This addendum (61 pages) shall form a part of and be included in the Contract Documents for the above titled project and no consideration will be entertained for extras to the Contract due to failure of the contractor to become thoroughly familiar with this addendum.

## ADDENDUM AD 03

<b>Project:</b>	Provincial Fire Life Safety – Lynn Lake, Gillam, and Thompson Sites	
<b>Commission Number:</b>	21569.44, 21569.49, 21569.50	SMS Project No.: 25-001-16
<b>Date:</b>	November 18, 2025	
<b>Pages:</b>	2 + 3 attachment/s

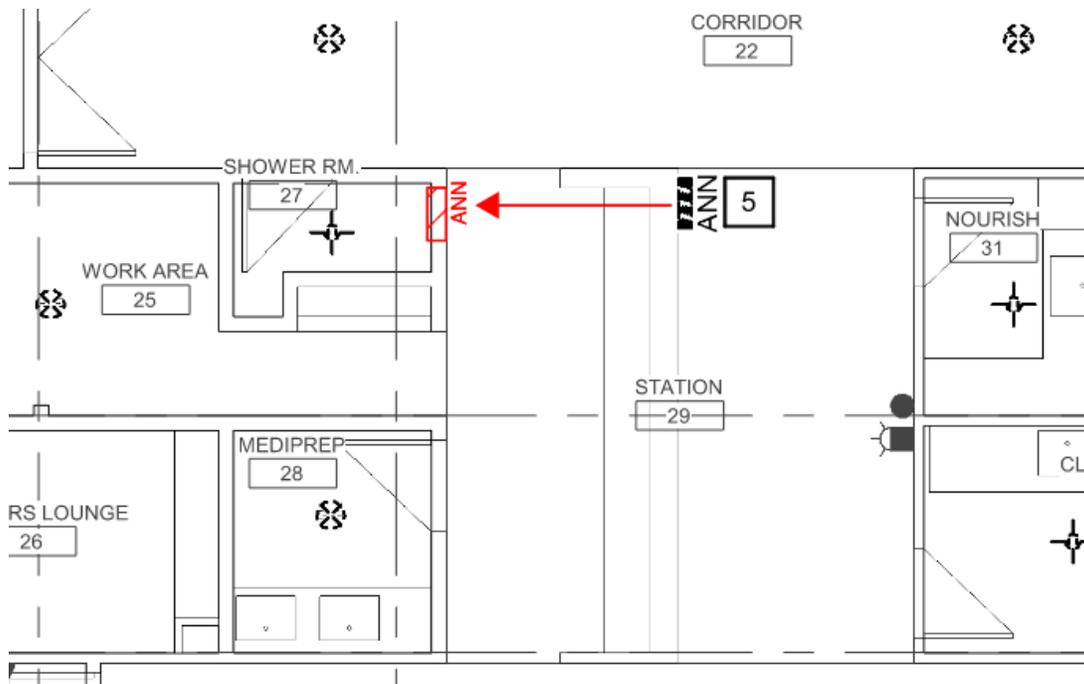
- .1 Refer to drawing E1-000 – Drawing List, Symbol Legend, General Notes and Electrical Details (addendum #2):
- .1 Provide new general note 'Q', to read as: *“Provide patching and painting as required to repair surfaces impacted by the electrical demolition and new construction, to restore surfaces to their pre-construction condition. Provide new ceiling tiles to replace damaged existing impacted by the electrical demolition and new construction.”*
  - .2 Refer to Detail 2 – Fire Pumphouse – Electrical Detail. Provide exterior lighting according to the below layout:

Refer to luminaire schedule revisions on E1-301 for type XWA specs. Wire and connect exterior lighting to new panel PH within pumphouse building, provide new dedicated circuit and 15A-1P breaker for exterior lighting. Exterior lighting to be controlled by integral photocells.

.5 Refer to drawing E1-221 – Main Floor Plan – Electrical – New Construction:

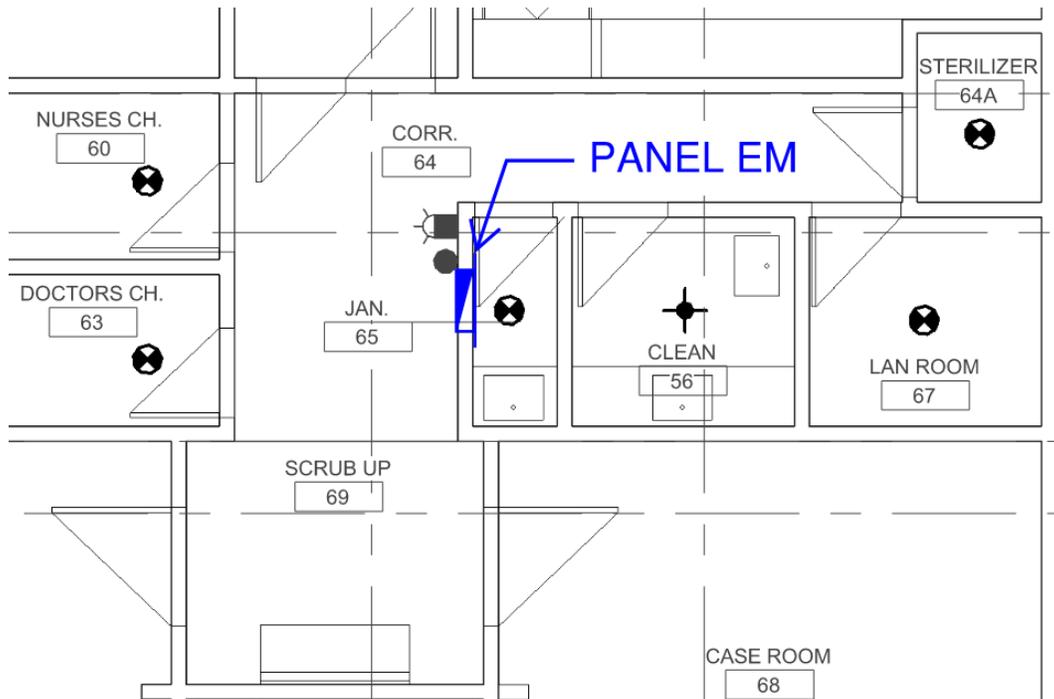
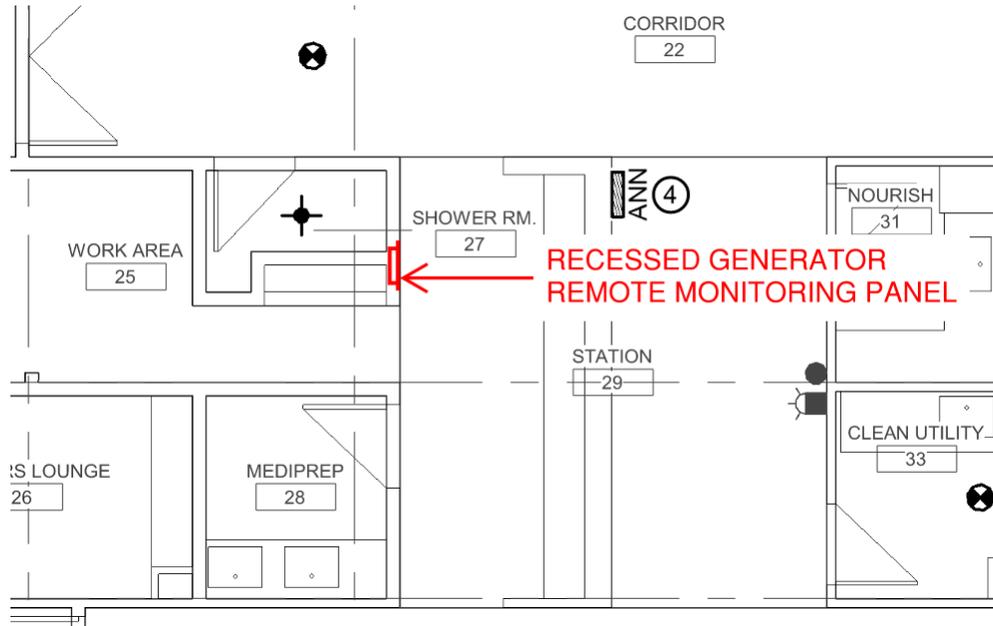
- .1 Wire and connect new fire shutter at pass through opening between Waiting Room 03 and Admitting Room 23. Wire and connect associated raise/lower control on wall adjacent to pass through opening. Refer to architectural drawing for exact location.

Provide new 120V emergency power circuit from existing Panel EM, and new 15A-1P breaker to match existing. Refer to below sketch for panel location:

Provide fire alarm relay at fire shutter to close shutter on general fire alarm (stage 2). Wire and connect to existing initiating loop serving area with capacity.

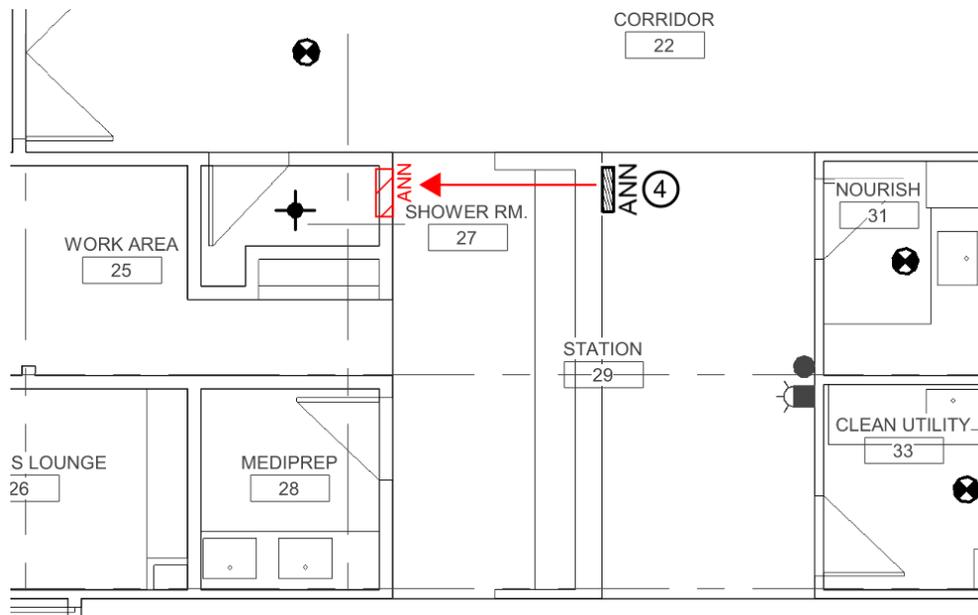
- .2 Wire and connect new sprinkler air compressor, FAC-1-01 on mechanical mezzanine above maintenance office 73A to existing emergency power panel E. Provide 15A-1P breaker to match existing, and local disconnect at equipment location.
- .3 Wire and connect new fire main recirculation pump, PP-1-03 in mechanical / electrical room 73 to existing emergency power panel E. Provide 20A-1P breaker to match existing, and local disconnect at equipment location.
- .4 Provide new recessed remote monitoring panel for new generator at nurse station 29. Confirm wiring type and power requirements with generator manufacturer. Refer to below sketch for approximate location.

- .9 Refer to drawing E2-211 – Basement/Crawlspace Plan – Electrical – New Construction:

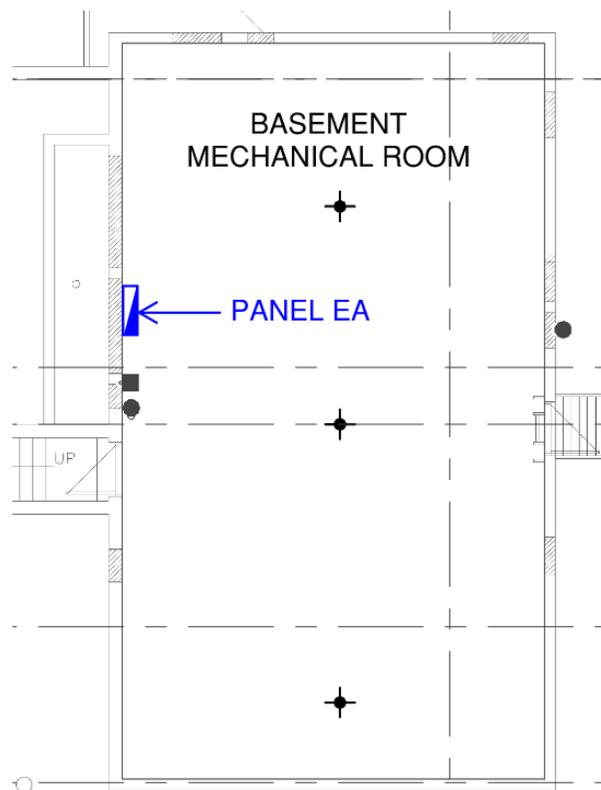
- .1 Revise AC-1 equipment tag to read as “FAC-2-01”  
.2 Revise FP-02-01 equipment tag to read as “FP-2-01”  
.3 Revise JP-02-01 equipment tag to read as “JP-2-01”  
.4 Reconnect existing jockey pump disconnected during demolition in new location on adjacent housekeeping pad (refer to demolition key note #7 on E2-111). Extend wiring and conduit as required.  
.5 Provide Emergency lighting battery bank and 2 x LED remote heads, sized for minimum 120 minutes runtime in the locations noted below. Provide receptacle c/w integral TVSS at high level next to each battery bank to supply battery bank charger, wire and connect to existing normal power lighting circuit serving each respective area. Coordinate exact locations on site:  
.1 Mechanical room B-03, to illuminate new fire pump FP-2-01 transfer switch / controller.  
.2 Electrical room B-04, to illuminate existing ATS.

- .13 Refer to drawing E3-221 – Main Floor Plan – Electrical – New Construction:
-

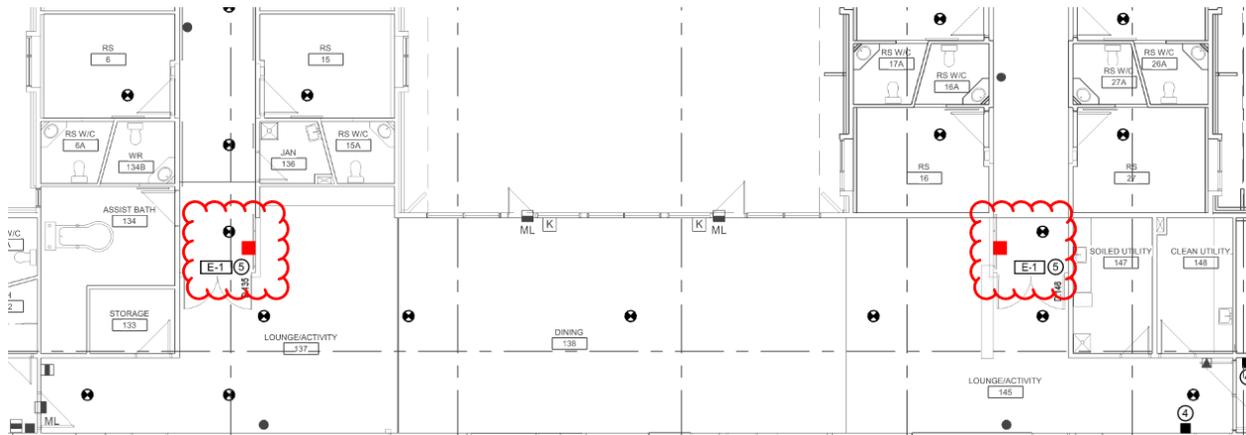
- .1 Wire and connect new magnetic door holders (total of 2) at new doors between corridor 135 and lounge/activity 137. Provide new 120V circuit from nearest existing normal power panel serving area with capacity and new 15A-1P breaker to match existing. Provide fire alarm relay(s) to release new door holders on fire alarm. Refer to fire alarm sequence of operation for further information.

- .1 Provide new smoke detector within lounge/activity 137. Smoke detector shall be installed on the centre line of the doorway to corridor 135 not more than 1500 mm from the doorway, measured along the ceiling, perpendicular to the doorway.

- .2 Wire and connect new magnetic door holders (total of 2) at new doors between corridor 146 and lounge/activity 145. Provide new 120V circuit from nearest existing normal power panel serving area with capacity and new 15A-1P breaker to match existing. Provide fire alarm relay(s) to release new door holders on fire alarm. Refer to fire alarm sequence of operation for further information.

- .3 Provide two (2) new fire alarm manual pull stations installed on new walls in the locations shown below, next to new doors at the ends of corridors 135 and 146, respectively:

- .16 Refer to drawing E4-213 – Ground Floor Plan – Block 3 – Fire Alarm – New Construction:

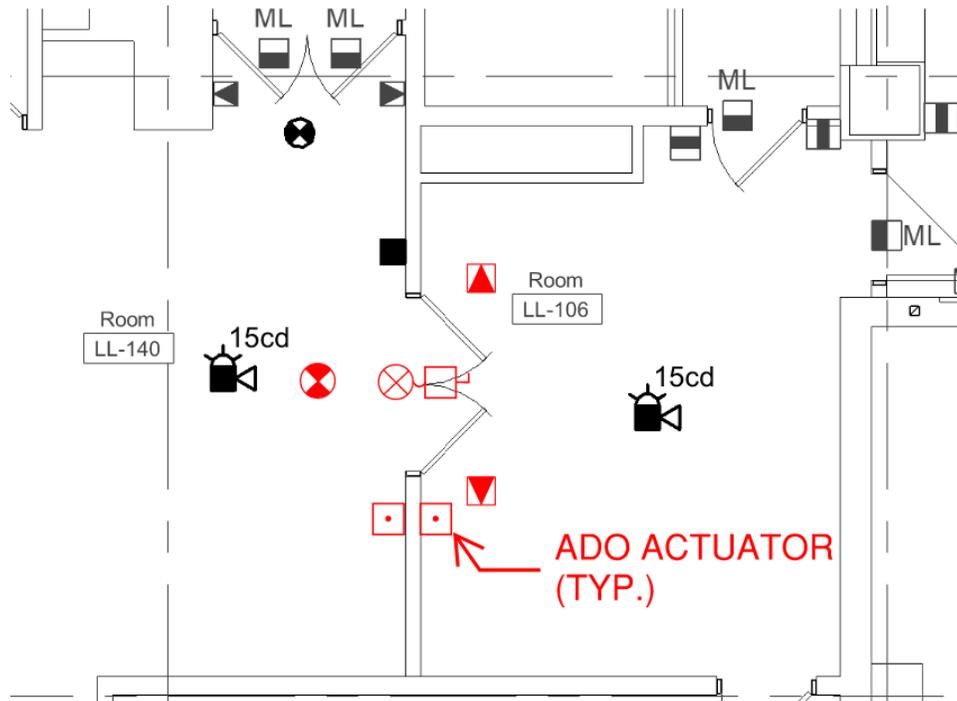
- .1 Wire and connect new automatic door operator (ADO) at doors between LL-140 and LL-106. Provide new 120V circuit from nearest existing normal power panel serving area with capacity and new 15A-1P breaker to match existing. Wire and connect new door operator actuators on either side of wall, see below sketch for location of actuators:

- .2 Wire and connect new magnetic door holders (total of 2) at doors between LL-140 and LL-106. Provide new 120V circuit from nearest existing normal power panel serving area with capacity and new 15A-1P breaker to match existing. Provide fire alarm relay(s) to release new door holders on fire alarm. Refer to fire alarm sequence of operation for further information.

- .1 Provide smoke detector within room LL-140. Smoke detector shall be installed on the centre line of the doorway to LL-106 not more than 1500 mm from the doorway, measured along the ceiling, perpendicular to the doorway.

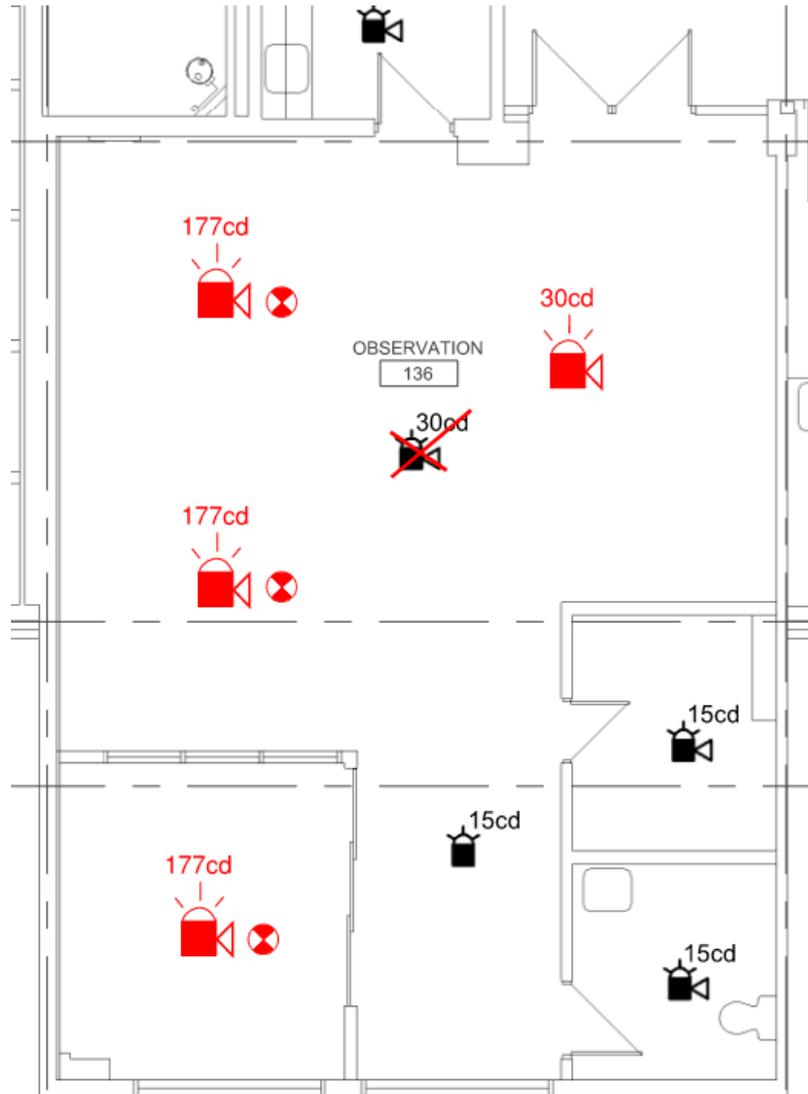
- .17 Refer to drawing E4-221 – First Floor Plan – Block 1 – Fire Alarm – New Construction:
  - .1 Refer to observation room 136. Provide carbon monoxide detectors of same manufacturer as the fire alarm system (not standalone), c/w sounder base to provide adequate coverage. CO detectors shall be monitored by the fire alarm system. CO detectors are permitted to be a combination smoke/carbon monoxide detector with sounder base.

Revise fire alarm device layout as below:

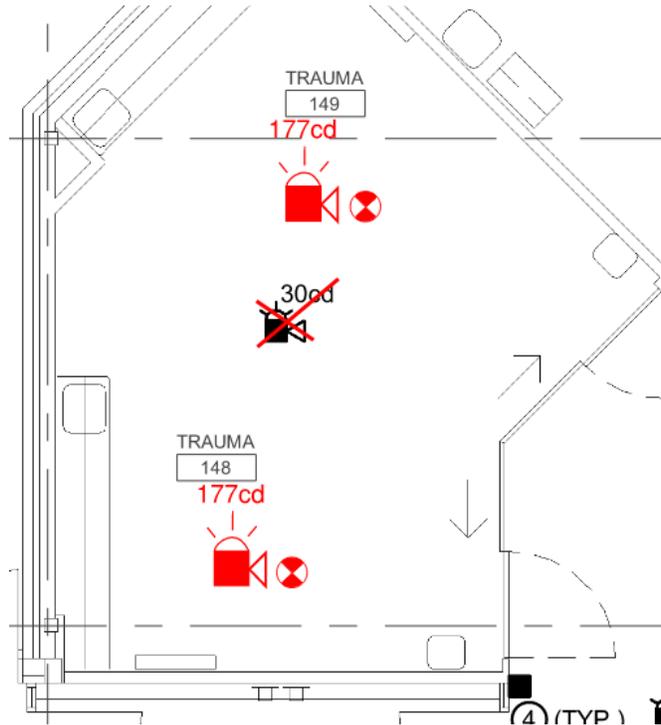
- .2 Refer to adjoining trauma rooms, 148 and 149. Provide carbon monoxide detectors of same manufacturer as the fire alarm system (not standalone), c/w sounder base to provide adequate coverage. CO detectors shall be monitored by the fire alarm system. CO detectors are permitted to be a combination smoke/carbon monoxide detector with sounder base.

Revise fire alarm device layout as below:

1 C1-200

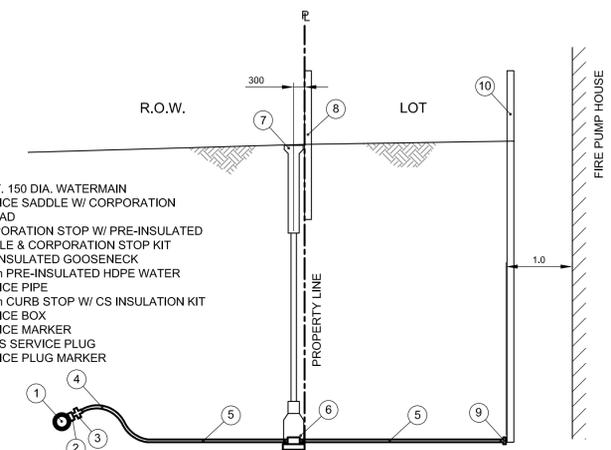
- .1 Refer to C1-200, Revision 1, dated November 6, 2025:
  - Add 38 mm HDPE pre-insulated recirculation water line with heat trace in common trench with 150 HDPE watermain fire service between pump house and hospital building.
  - Add minimum heat trace rating for 25 mm and 38 mm water service piping of 3 watts per foot for each.
  - Add 25 WM curb stop at the connection to the municipal watermain return.
